SUNDRY NOTICES AND REPORTS ON WELLS

PLUG AND ABANDONMENT PROCEDURE

Dr John #1

API 30-037-20083

Current Wellbore
Wildcat Pennsylvania
1650' FNL & 990' FWL, Section 13, T10N, R27E
Quay County, NM, API# 30-037-20083

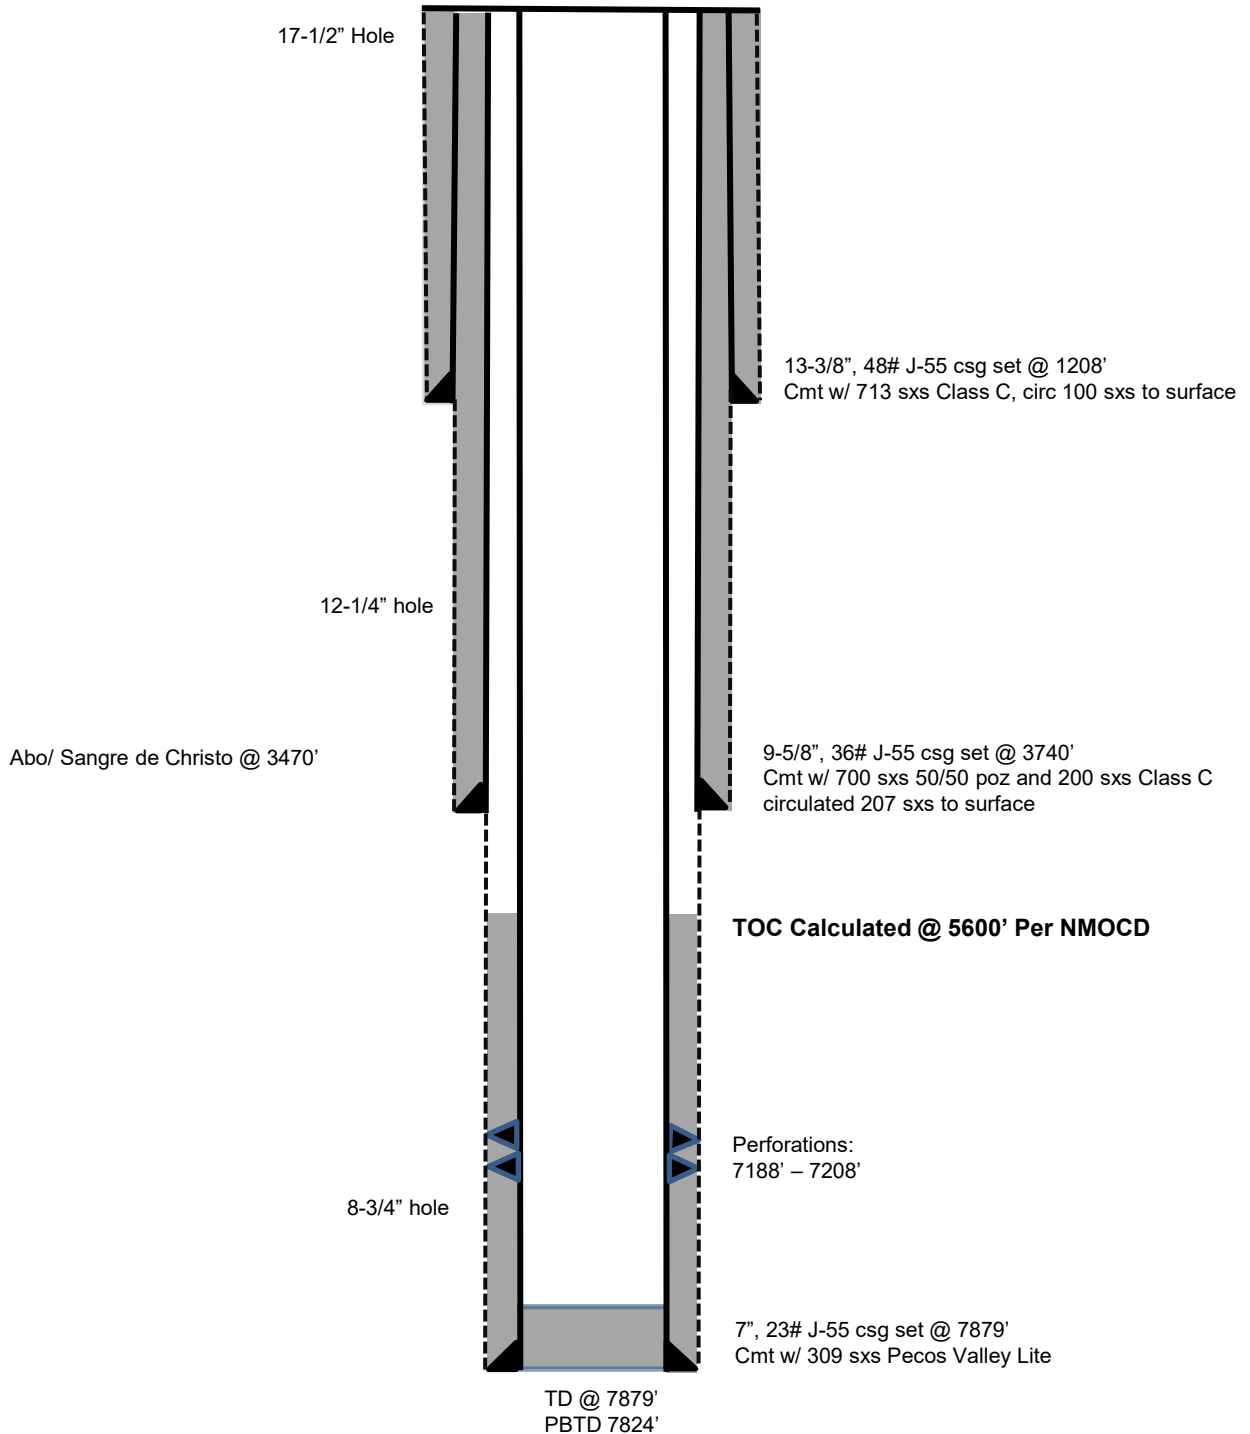
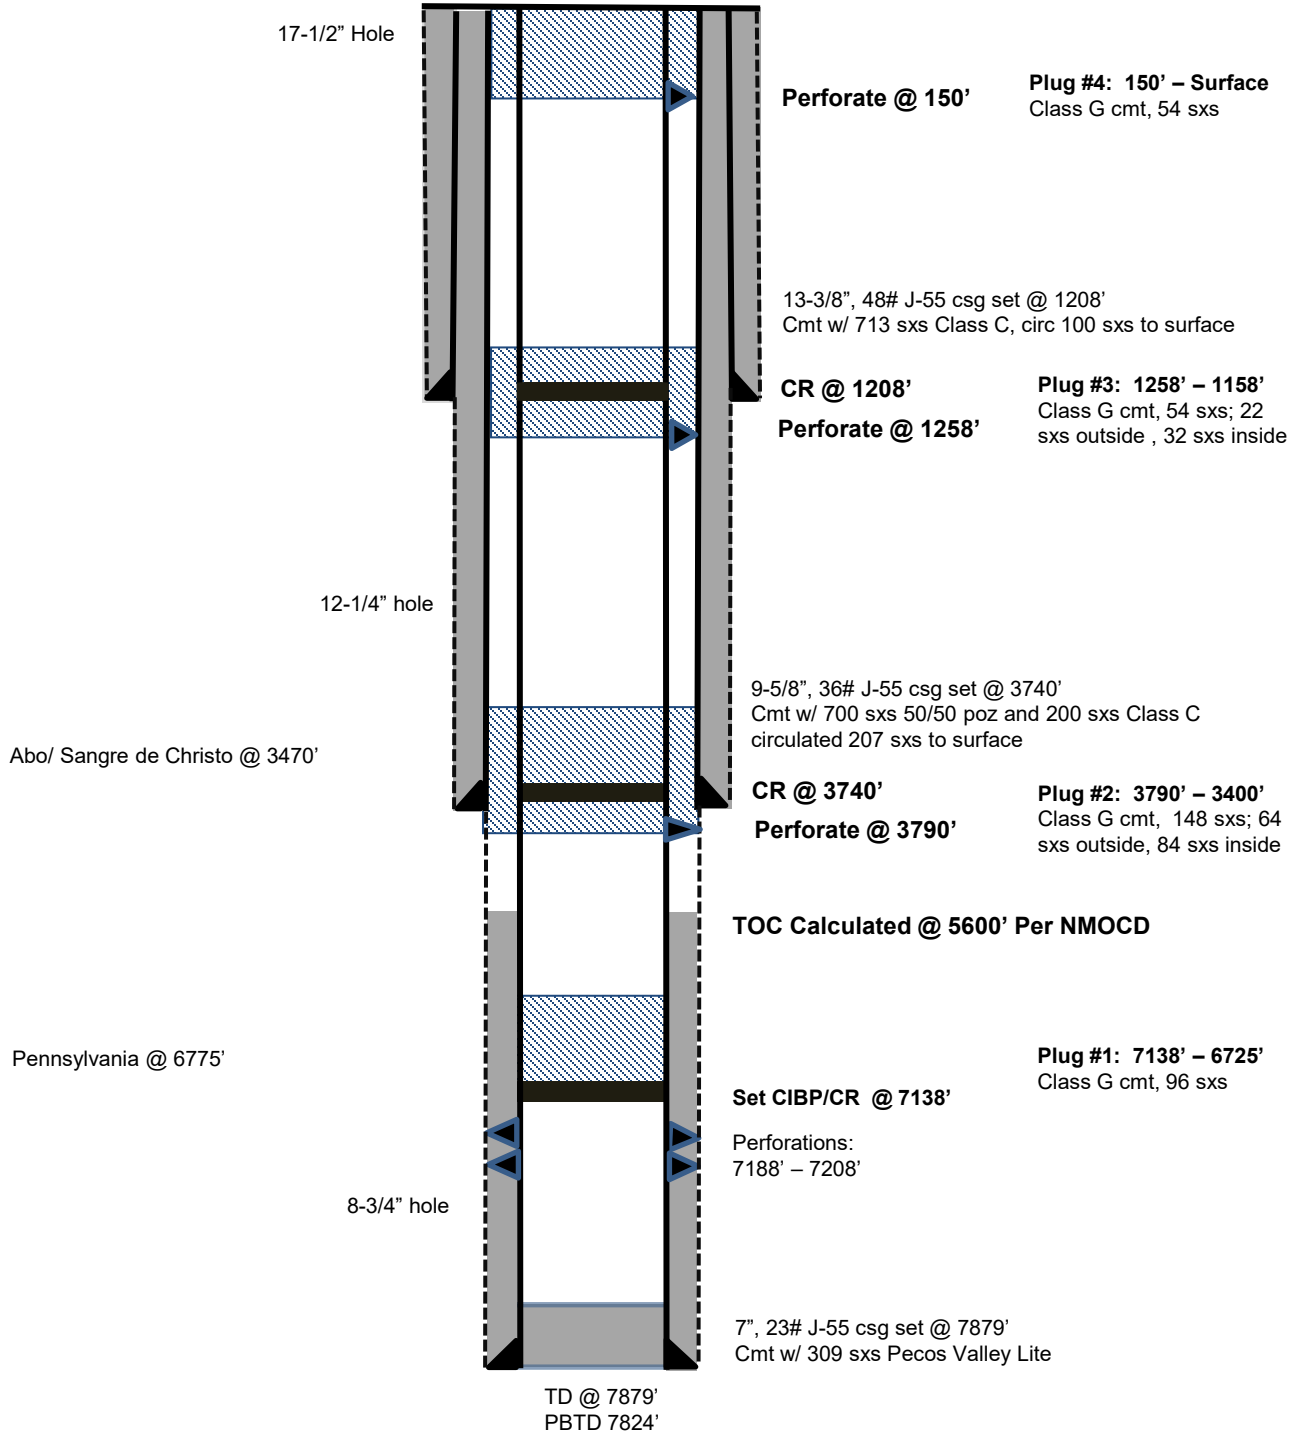
Created By	Condition	Condition Date
mkuehling	Notify NMOCD 24 hours prior to moving on - monitor string pressures daily report on subsequent -CBL is required - submit all logs prior to subsequent - extend Pennsylvania formation plug - if pressure exists on bradenhead or intermediate after plug 3 will need to discuss with NMOCD prior to proceeding - WOC and tag after each plug - weight of cement on H is 16.5	10/9/2024
mkuehling	- add additional plugs -Granite 6514 - Cisco 5940 - Wolfcamp 5167 Tubb 4004 Yeso 2828 Glorieta 2644 San Andres 1682 - Santa Rosa 1000 - ground water top at 339	11/19/2024
